Department of Planning and Zoning

TO: Development Review Board
FROM: Scott Gustin
DATE: March 19, 2013
RE: 13-0749CA/CU; 367 Appletree Point Road

Request: Construct new accessory apartment and associated site improvements

PROJECT		DRAWING		LOCATION	
CHRIS AND BROOKE GILLMAN		IN-LAW COTTAGE ELEVATIONS + SECTION		BURLINGTON, VERMONT	
FILE	GILLMAN	ISSUE	FOR PERMITS	SCALE	3/16"=1'-0"
				DATE	02.18.13
				REVISION

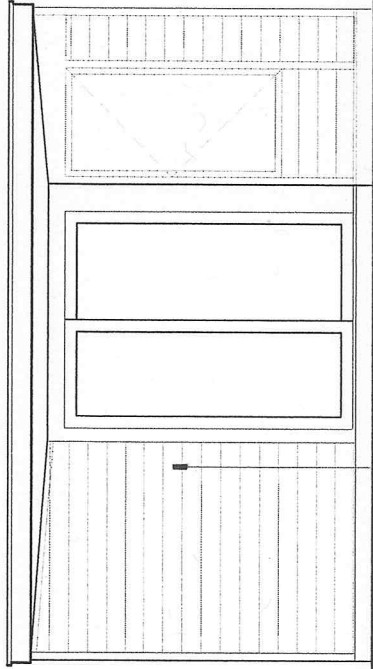
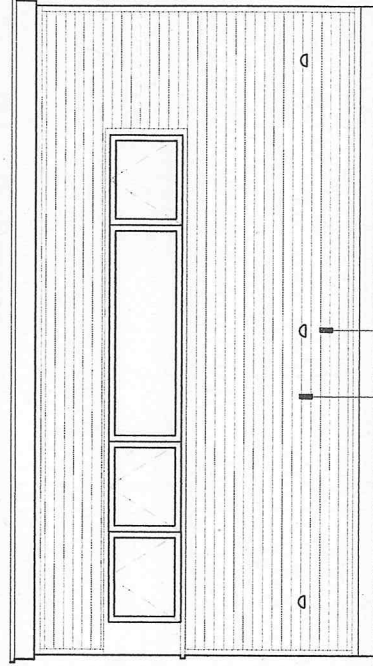
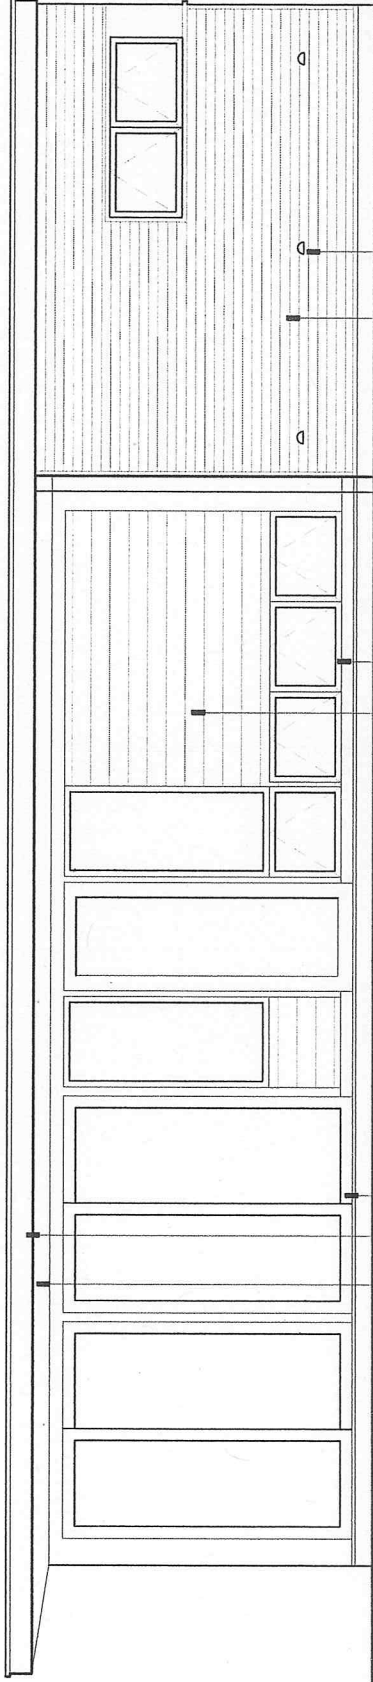
Proposed outdoor lighting consists of several wall-mounted sconce fixtures and one flood light fixture. The sconce fixtures are acceptable cutoff units that will illuminate the walkway and patio areas adjacent to the proposed accessory dwelling unit. The flood light is proposed to illuminate the parking area immediately to the north of the proposed accessory dwelling unit. Typically, flood lights are not permitted; however, the proposed fixture is shielded and utilizes "low output" bulbs producing only 1,500 initial lumens. The fixture is acceptable. As noted before, the parking space it would illuminate is unacceptable. The proposed flood fixture must be relocated to the west (over the driveway) or deleted. No lighting is depicted over the doorway. If entryway lighting is proposed, it must be depicted on the elevation plans, and a fixture cutsheet must be provided. **(Affirmative finding as conditioned)**

- b. Deletion of the parking space immediately in front of the accessory dwelling unit;
 - c. Deletion or reposition of the floodlight fixture to the west side of the new building;

- d. Depiction of doorway lighting and associated fixture cutsheet (if proposed); and,
 - e. Utility meter location and screening (if proposed).
2. **EPSC Pre-release Condition:** Prior to release of the zoning permit, the applicant shall obtain written approval of the Erosion Prevention and Sediment Control Plan from the Stormwater Administrator.

PROJECT	DESIGNER	LOCATION
CHRIS AND BROOKE GILLMAN	IN-LAW COTTAGE SITE PLAN	BURLINGTON, VERMONT
FILE	ISSUE	FOR PERMITS
GILLMAN	02.18.13	02.18.13
DATE	SCALE	REVISION
02.18.13	1"=20'	02.18.13

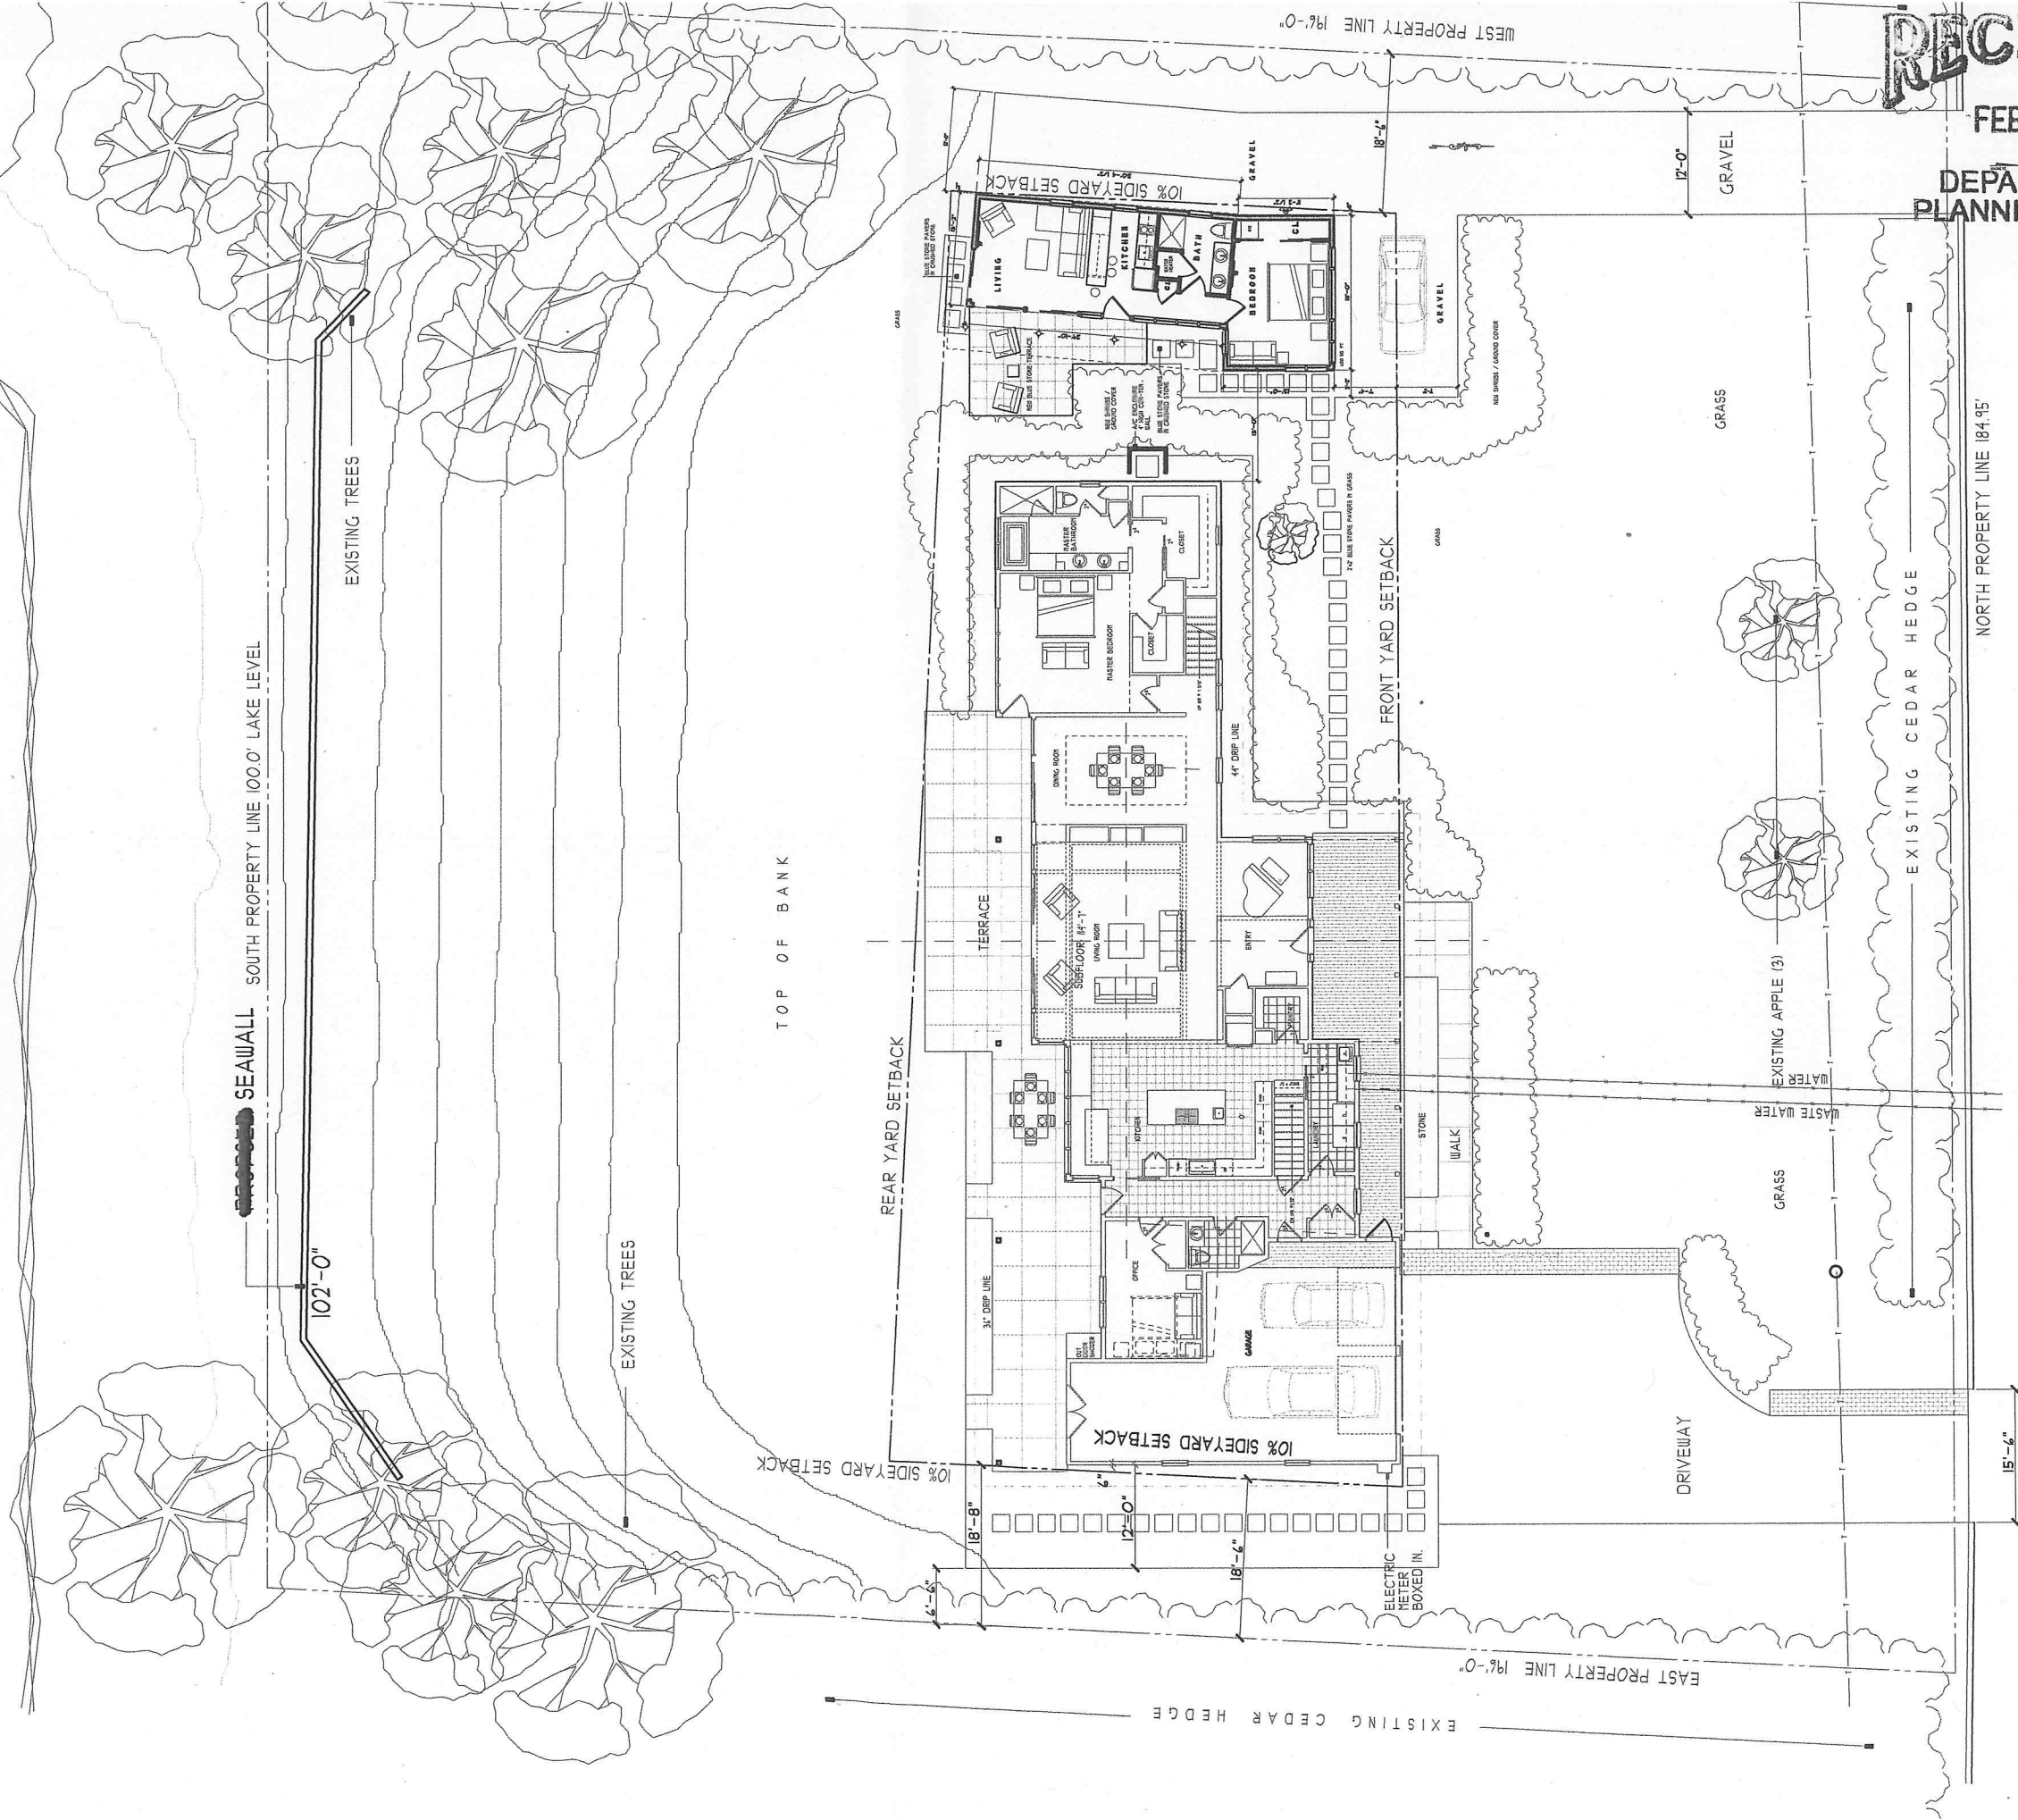
The accessory dwelling unit, at just 10.5' tall, is subject to a 5' side yard setback. As proposed, it will be set back 18.5' from the side boundary line. The proposed driveway is also subject to a 5' side yard setback. As proposed, a portion of the driveway encroaches into the setback as it nears the road. The driveway must be shifted eastward to comply with the 5' setback for its full length. The proposed accessory dwelling unit complies with the 75' lakeshore setback and with the front yard setback. The parking spot proposed in front of the accessory dwelling unit encroaches into the front yard setback and cannot be permitted. This space must be deleted. The driveway is sufficiently long enough to contain the required parking without this space.

The proposed driveway is of sufficient dimensions to contain the required two parking spaces. As noted above, the single parking space in front of the accessory dwelling unit must be deleted due to its location partially within the front yard setback. **(Affirmative finding as conditioned)**

(m) Landscaping and fences
New shrubs and ground cover similar to that around the primary residence is proposed for the accessory dwelling unit. A section of new plantings intended to screen the front parking space may be reworked, as the front parking space must be deleted. No new fencing is proposed.
(Affirmative finding)

The accessory dwelling unit requires 2 parking spaces. The proposed driveway is of adequate dimensions to contain the required parking. As noted previously, the parking space immediately in front of the proposed dwelling unit amounts to front yard parking under Sec. 8.1.12, (c), *Front Yard Parking Restricted*, and must be deleted. **(Affirmative finding as conditioned)**

1. **Prior to release of the zoning permit**, revised plans shall be submitted subject to staff review and approval. Revised plans shall depict:
 - a. A new driveway that complies with the 5' side yard setback for its entire length;
